Rezoning Transportation Analysis

Petition Number: 2021-178

General Location Identifier: 07706303

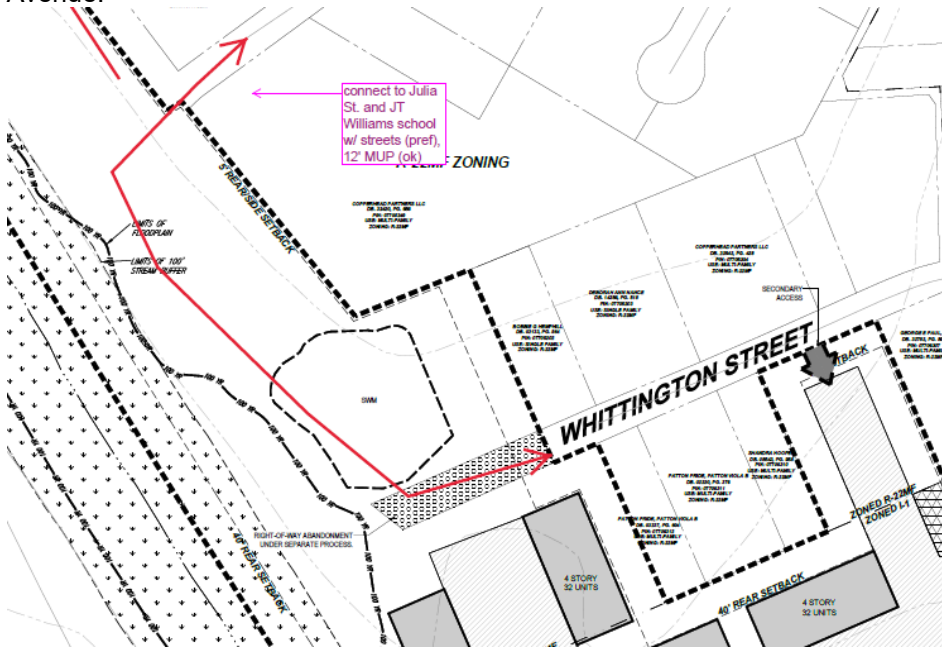
3. Revise site plan and conditional note(s) to commit to dedicate 28 feet of right-of-way from the road centerline of Whittington Street. The site plan shall label and dimension the right-of-way from the road centerline.

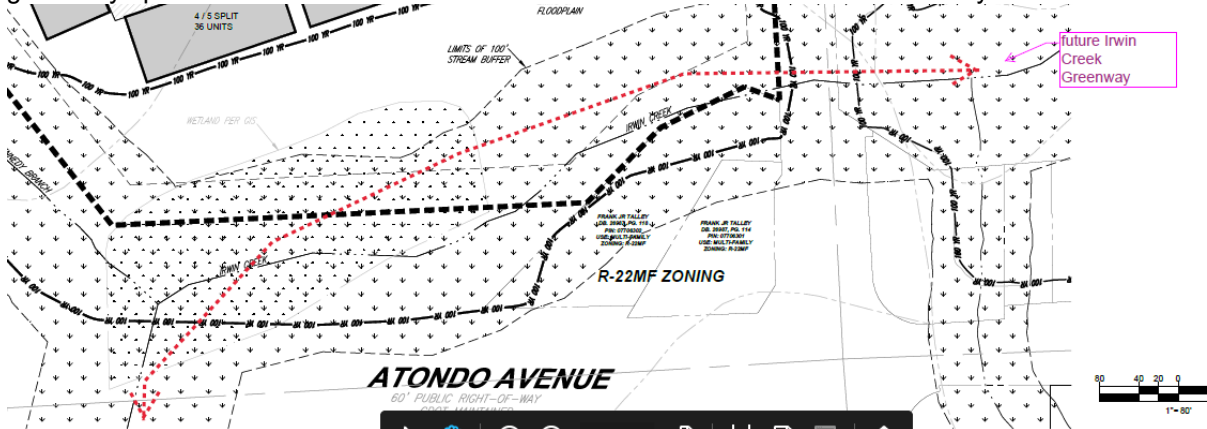
10. Revise site plan and conditional note(s) to commit to construct an 8-foot planting strip, and 6-foot sidewalk on Whittington Street per Chapter 19. The site plan shall label and dimension both items from the back of curb and gutter and road centerline.
11. Revise site plan and conditional note(s) to commit to installing a local residential median street per CLDSM U-02 (**Request**) or a 12-foot multi-use path (**Required**) connecting Whittington Street to Julia Avenue.
